20-COA-0010
1249 Everett Avenue

Cherokee Triangle Architectural Review Committee
Public Hearing

Kat Groskreutz, Historic Preservation Specialist
July 08, 2020

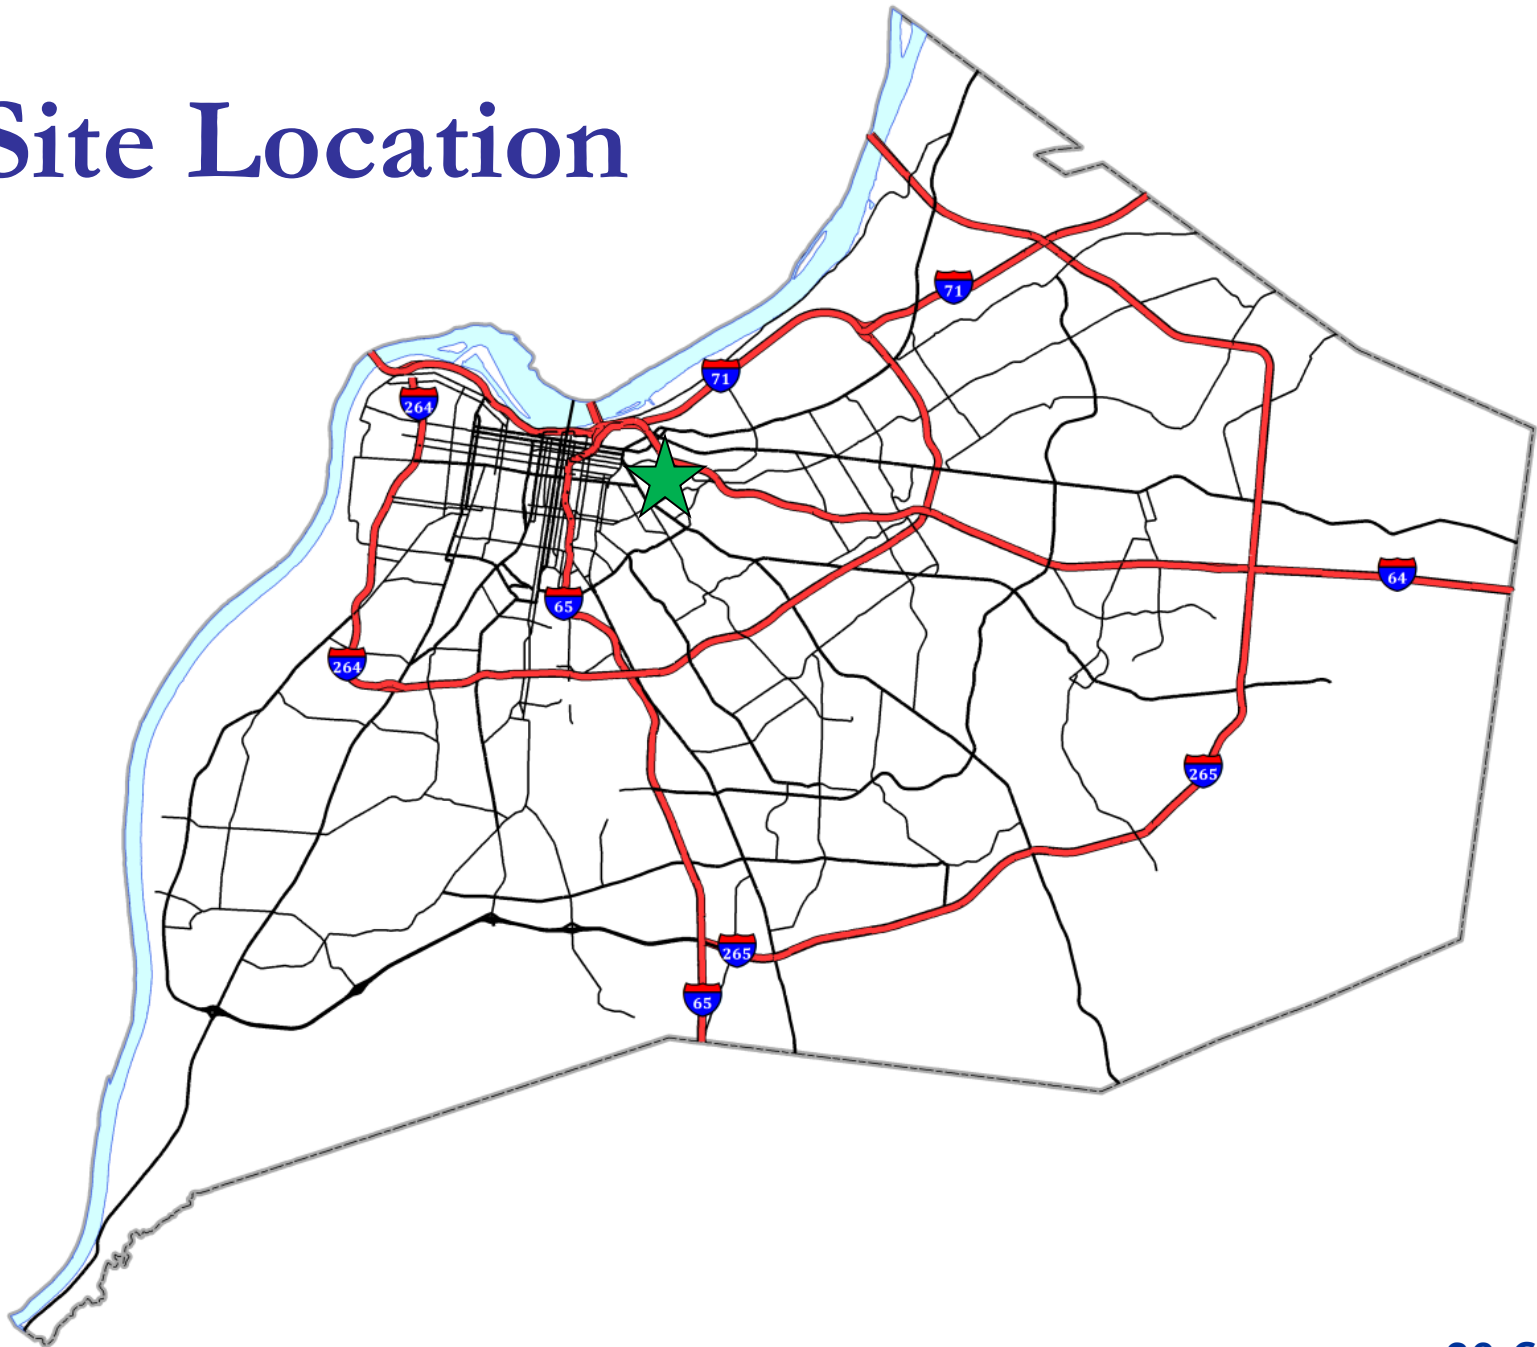
- The interior window sills and the bottom portions of the jambs show some signs of deterioration and water damage.
- There is paint alligatoring on both which is partially obscuring the condition of the wood underneath.
- One of the storm windows is no longer flush with the bottom of one of the windows which may be allowing water into the sill.
- The interior sashes do not appear to be severely deteriorated.

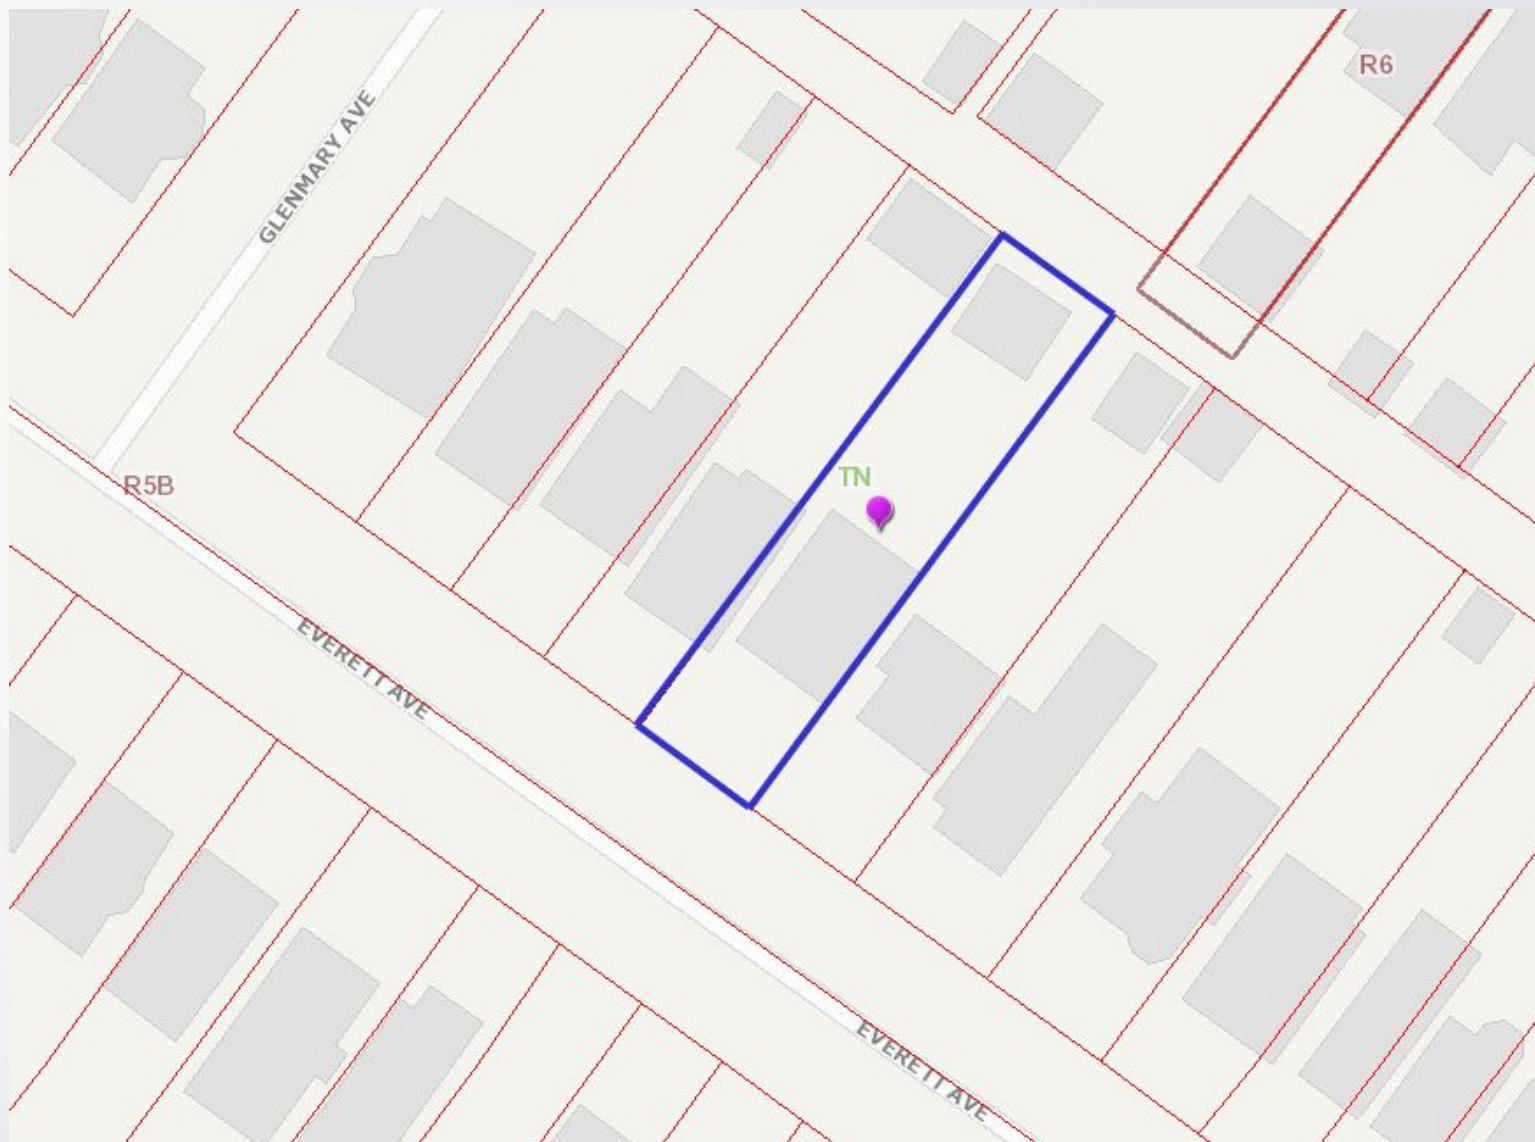
- The previous window-for-door replacement COA was restoring the home's historic fabric.
- The existing windows proposed to be removed and replaced are wood and original to the home.
- One of the storm windows is no longer flush with the bottom of one of the windows which may be allowing water into the sill.
- The interior sashes do not appear to be severely deteriorated.
